MEMORANDUM

From:	Duncan Fisher Ecology Officer		
Service	WBC Ecology	App No:	250517
Address:	Land Off Basingstoke Road, To the south and west of Spencers W.		
Proposal:	Hybrid planning application (part outline/ part detailed) comprising: Outline planning permission is sought with all matters reserved for future determination, save for the means of access via Basingstoke Road, for: up to 420 dwellings (Use Class C3), an 80 bed care home (Use Class C2), 1ha of employment land (Use Class E(g), primary school (Use Class F1), local centre (Use Classes E(a), (b), (c), (f)), GP Surgery (Use Class E(e), sports pitch and changing facility, public open space and a full application for the proposed Suitable Alternative Natural Greenspace (SANG), associated landscaping/car park.		
Type of Development:	Major All other developments		
Site Visit Made:	Yes/No

Thames Basin Heaths SPA

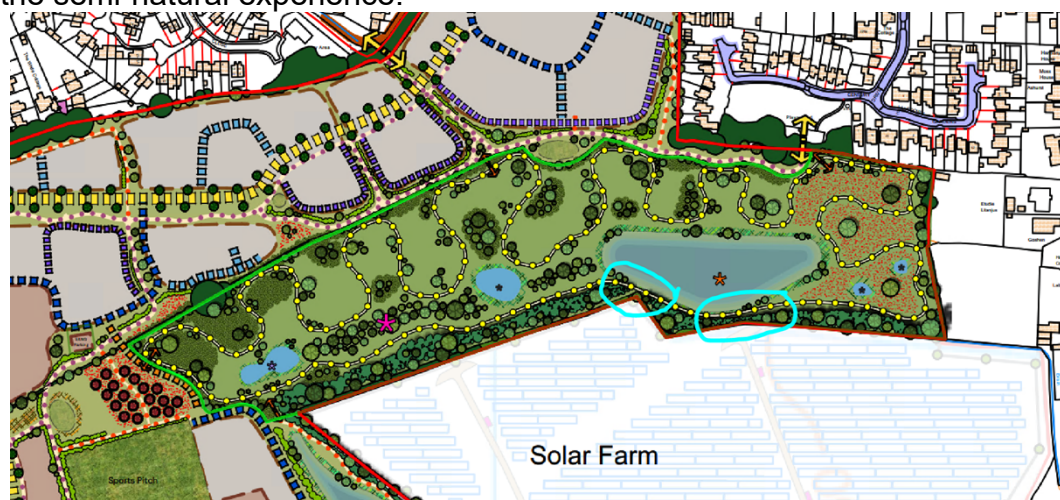
1. The 2.3km circular path is contrived – needing seven loops wiggling across its northern route to get sufficient length. The Natural England guidance recommends to:

“Avoid convoluted paths and pinch points in SANG design. By maintaining a minimum width between paths of 100 m in open ground and 50 m in dense woodland.”

The vast majority of the SANG circular walk is well within 50m of other sections of itself and the SANG is not dense woodland. The image snip below shows a buffer analysis of the circular walk (orange) and 10m, 15m, 20m, 25m, 30m, 35m, and 40m ring buffers.

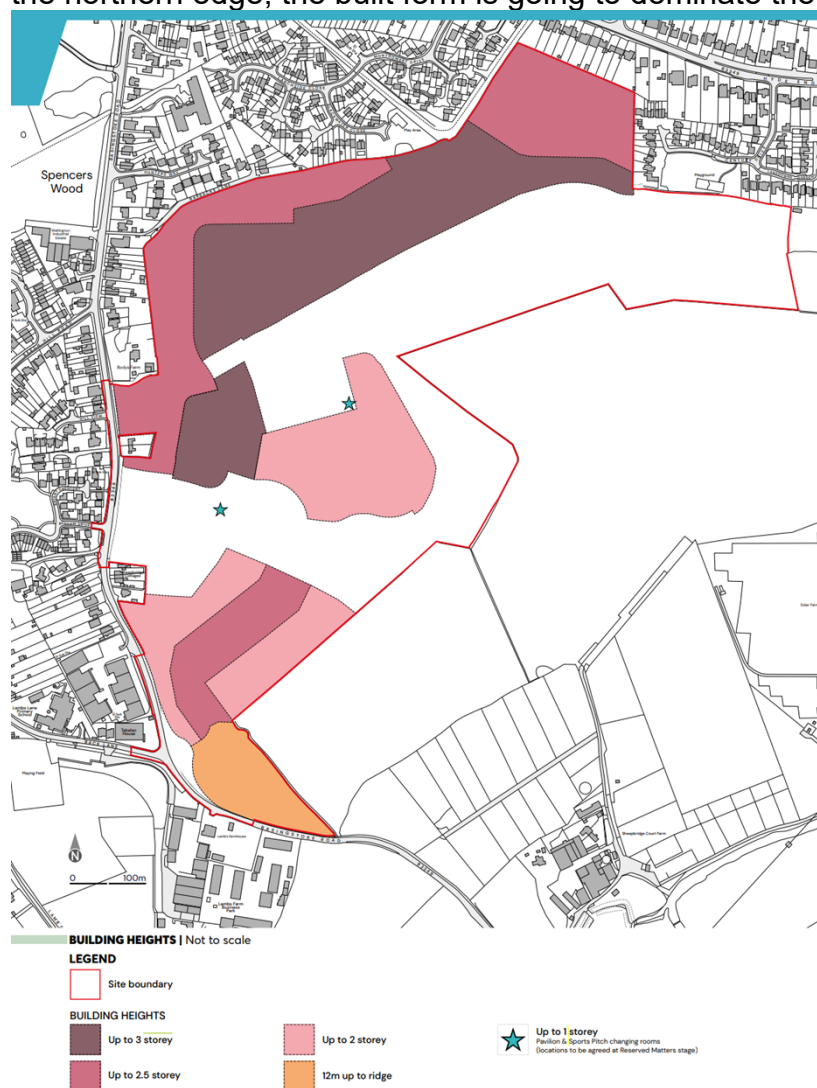
2. The proposed woodland planting along the southern edge – to screen the solar farm – is very thin with locations where it is less than 10m across as the circular walk is pinched between the SuDS basin and the boundary (see the locations highlighted in

light blue in the image snip below). This will result in an ineffective screen reducing the semi-natural experience.

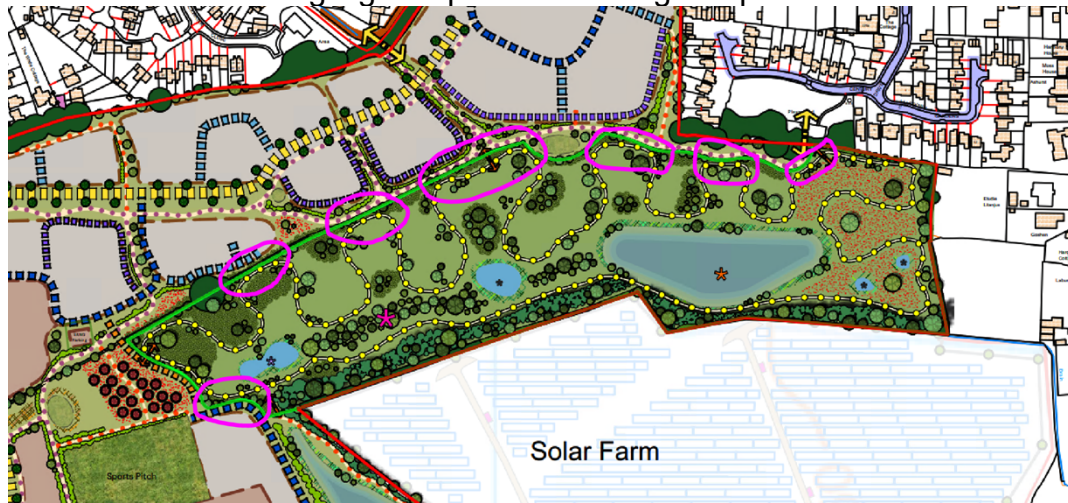
3. Also adding to the urbanisation, it is proposed that the development blocks to the immediate north of the SANG are up to 3 storeys high. Given that there are significant parts of the circular walk that run close to the perimeter of the site along the northern edge, the built form is going to dominate the visitor experience.

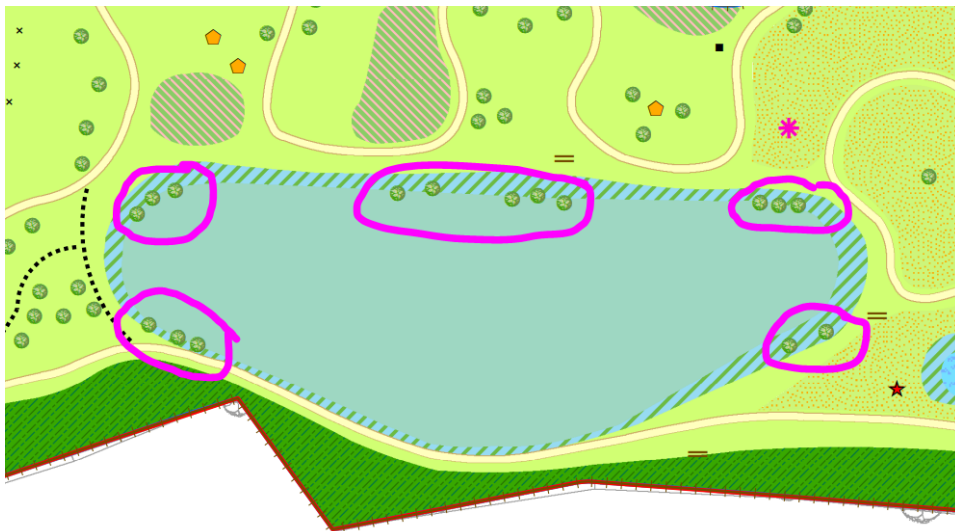
4. The submitted Lighting Strategy indicates that the secondary movement routes, tertiary streets and primary cycle routes would be lit. Whilst there is no proposal to light within the SANG itself, the lighting will have an urbanising impact on the circular walk because the circular walk is forced to be so close to the perimeter of the SANG – see the locations highlighted pink in the image snip below.

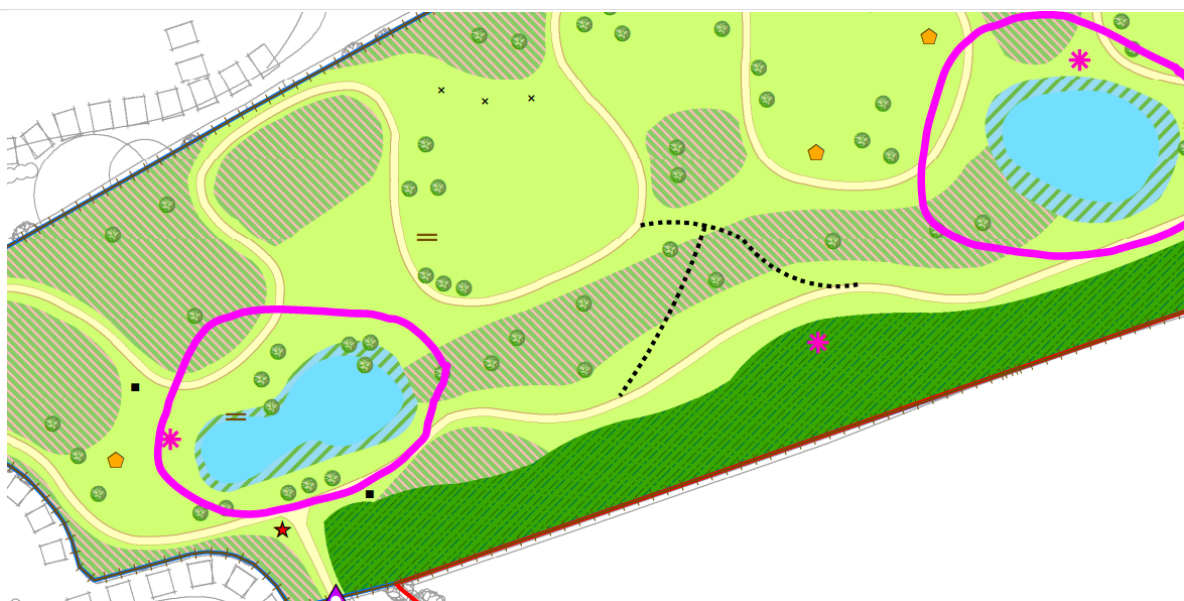
- b) The doggy trim trail is a good idea but its location undermines the circular walk by creating a shortcut desire line:
